Request for Information 020

Halliburton - OJ, AcidFree & Wash Bay Facility
3100 D Road
Grand Jct., CO 81504

Subject	Discipline	Category
Entry/ Exit Aprons of Wash Rack Terminal	Mechanical	Clarification

Subject	Discipline	Category
Door Relocation at Wash Rack Terminal	Architecture	Request for Information

A2.1

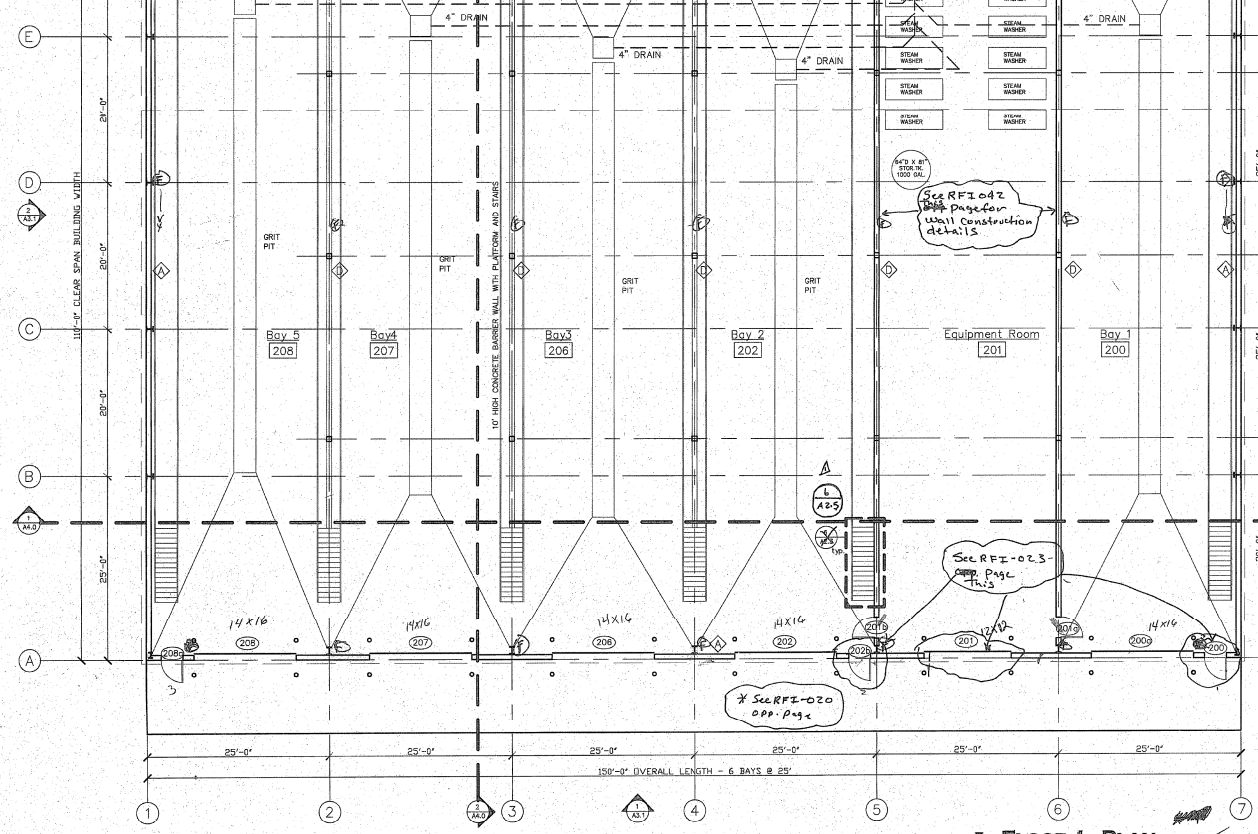
Ref: Sheet A2.1, S1, WMP-1

Per clarification at owners meeting on 2/1/2007, the entry/ exit aprons at the Wash Rack Terminal which cover the area between column lines 1 through 7, will extend out from the building 25 feet. A2.1, S1 show the aprons sized incorrectly. WMP-1 shows the correct size of the entry/ exit aprons represented with a dotted/ dashed line.

Confirming RFI, NO RESPONSE REQUIRED.

Door Relocation at Wash Rack Terminal

Doors on the Wash Rack building are to be relocated as follows:

1. Grid overhead door #205 from last bay to column line E.
2. Move door #206 to the right of column line D.
3. Move door #208 to the right of column line A.
4. Move door #209 to the right of column line A.

Per a phone conversation with John Galloway on 2/6/2007, moving the doors to the above mentioned locations is acceptable.
